Illinois Tollway Base Sheet Revisions

Section M	Base Sheet Drawings		
	Drawing	Modification Summary	Effective: 03-01-2023
	Overhead Sign (OHS)-Series 720		
	M-OHS-729	OVERHEAD SIGN STRUCTURE ITS GANTRY FRAME (STEEL) SINGLE SPAN STRUCTURE DETAILS

VERSION: 2023-03	STANDARD: M-OHS-730	SHEET: 7 OF 9
---------------------	------------------------	------------------

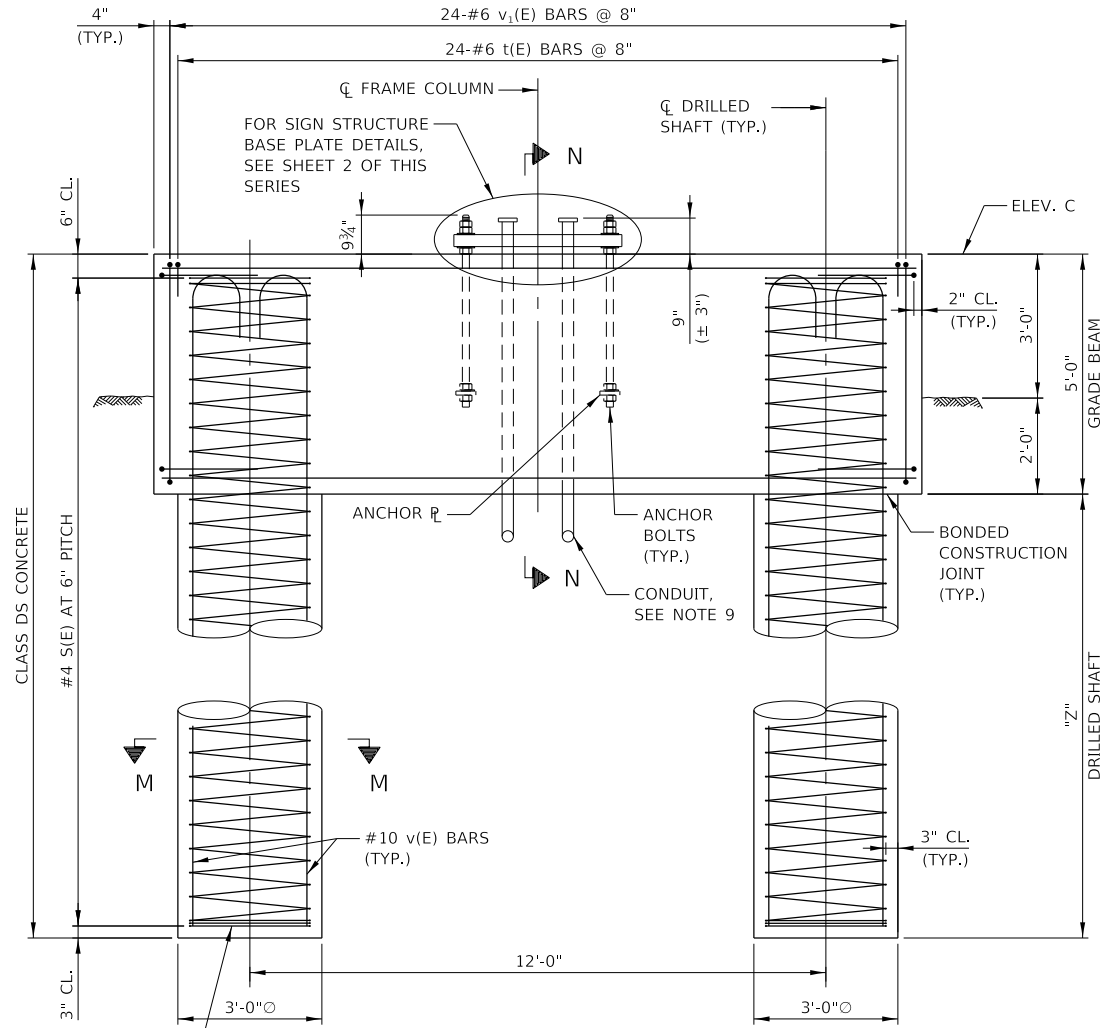
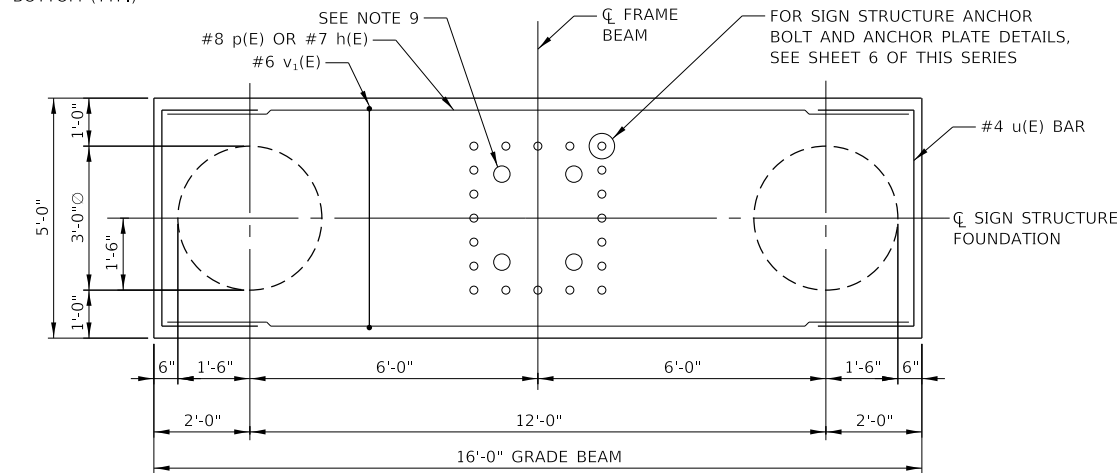
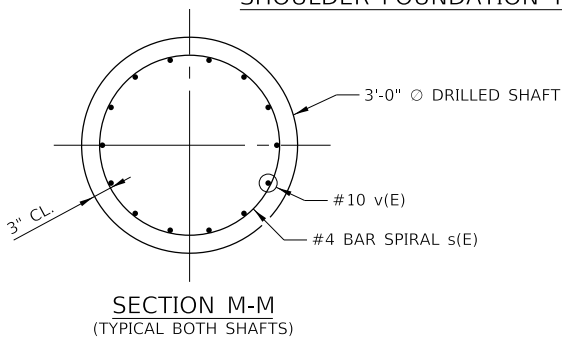
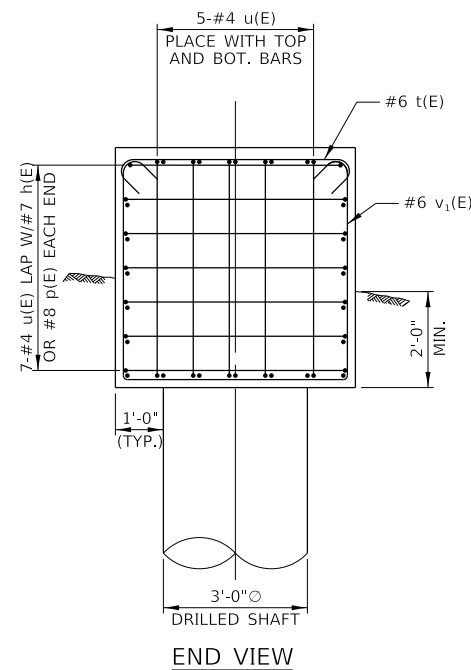
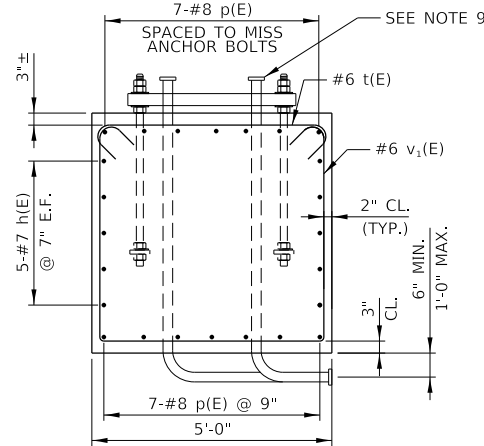
Sheet 7	Revised v(E) bar lengths, updated total bar weights and added note 10 referencing location of "W" and "X" dimensions.		
Sheet 8	Removed cost included in the cost of "Foundation for ITS Gantry Frame" from note 2. Revised number of of v(E) bars in bar schedule, update reinforcement weight and Section S-S.

10. SEE SHEET 6 FOR DIMENSIONS "W" AND "X".
